NASA Electronic Parts and Packaging (NEPP) Program 2017 Electronics Technology Workshop

NEPP Program Task 17-294 Government Working Group

June 27, 2017

X-ray highlighting voids in lid seal solder

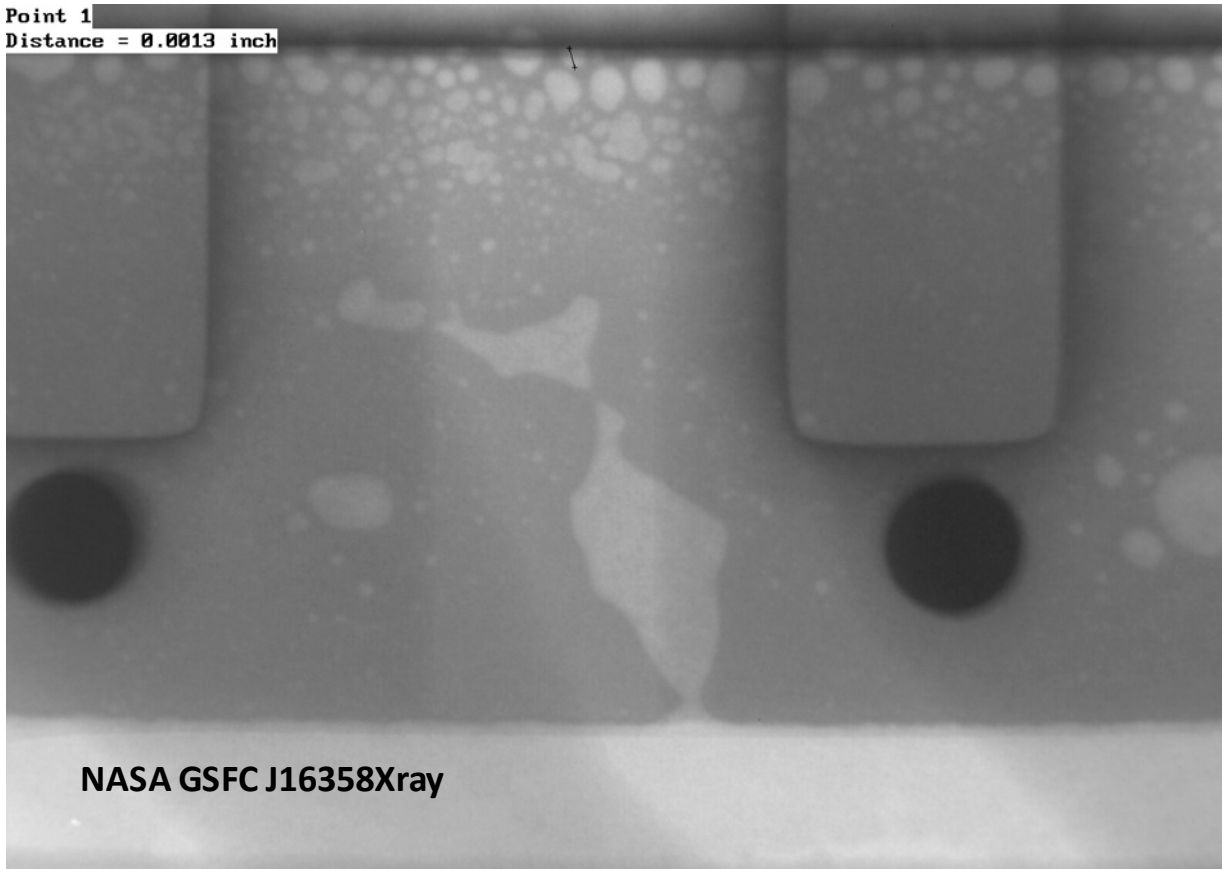
- **Developed a unified government position to address Analog Devices (AD)/Infineon International Rectifier (IR) proposal to reduce the MIL-STD-883 TM2012 X-ray design seal width.**
 - Proposed maximum 75% void criteria be reduced to 5% during October 2016 and January 2017 SSTC-G12/JEDEC task group meetings
 - Change based on X-ray rejects of only 4 part types with Au/Sn solder sealed lids subjected to and passing temp cycling or temp cycling and thermal shock testing
 - AD – Tested four 52-lead ceramic quad flat pack devices
 - 1000 -65/+150C temp cycles followed by leak testing
 - IR – Tested 28 SMD 0.2, 98 SMD 0.5, and 448 UB devices
 - 100 -55/+150C temp cycles, leak testing, 400 -55/150C temp cycles, leak testing, 20 cycles thermal shock, leak seal

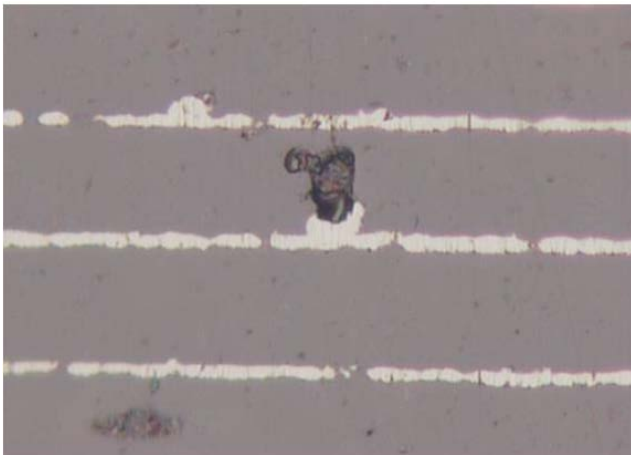
- **Letter signed by all five government agencies, rejecting change, sent to DLA Document Standardization Division and to JEDEC/SSTC-G12 chairs.**
 - Relaxing the criteria from 75% to 95% voiding does not provide confidence in long term reliability
 - Need to maintain process control and to have a robust package seal
 - 95% voiding will reduce manufacturers' continuous improvement efforts to optimize the seal process and could ultimately result in an inferior product
 - AD and IR both admitted operators could not discern 95% voiding
 - 75% voiding criteria has been in both MIL-STD-750 and 883 radiography inspection methods for over 30 years
- Letter equally applies to MIL-STD-750 TM2076.

Scanning Electron Microscope (SEM) Image of Same Void
Source: NASA GSFC J15135DPA

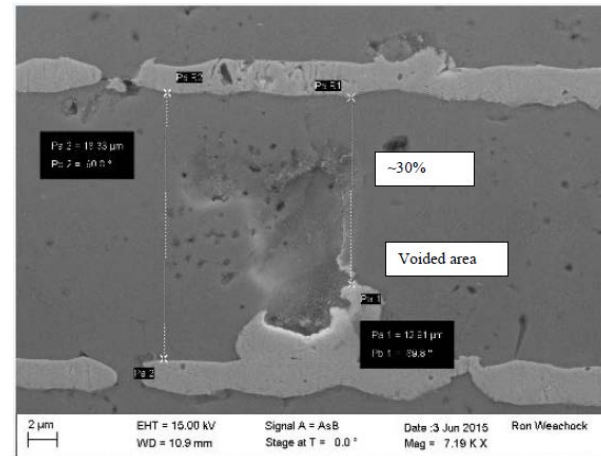
- **Draft of MIL-PRF-32535A does not require inspection of voiding or nonuniformities in dielectric layers $< 7\mu\text{m}$.**
- The following change was proposed and accepted
 - A dielectric evaluation method for layers $< 7\mu\text{m}$ was added, which includes using SEM to determine if 50% voiding is a result of manufacturing defects or DPA artifacts.

NASA GSFC J13016DPA

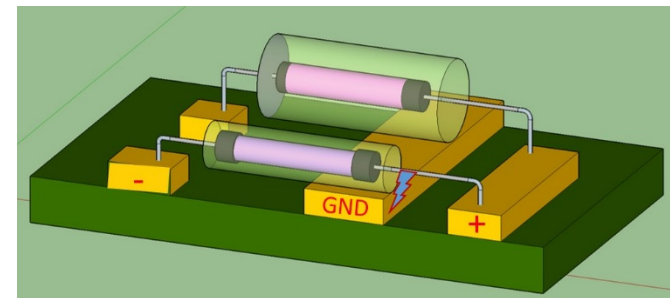
- **Compiled 26 comments and submitted to DLA for review.**
 - 24 comments were resolved and will be incorporated in an updated Rev K draft
 - 2 comments are unresolved and will require further discussion with SSTC-G12, JEDEC, and DLA
 - Current wording allows Group C lot qualification electrical failures to be used for subsequent IGA testing. However, if there are electrical failures, the lot fails and a new qualification lot must be selected.
 - Rev K deletes the requirement for WCCA. Due to hybrid complexity, WCCA is essential to ensure no element is driven beyond its design limit.

NASA GSFC J16443DPA

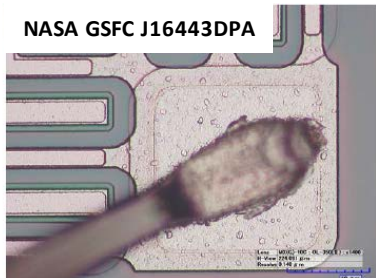
- **MIL-PRF-19500 Major Change Definitions and Required Notification**
 - During a DLA M19500 manufacturer audit, an auditor noted a major change was made to the bond wire process step. DLA was not notified.
 - M19500 adequately defines major changes and required requalification testing. A bond wire process change is listed as a major change but M19500 does not specifically state manufacturer is to notify DLA of major changes.
 - In this case, manufacturer had performed all required requalification, but did not notify or provide data to DLA.
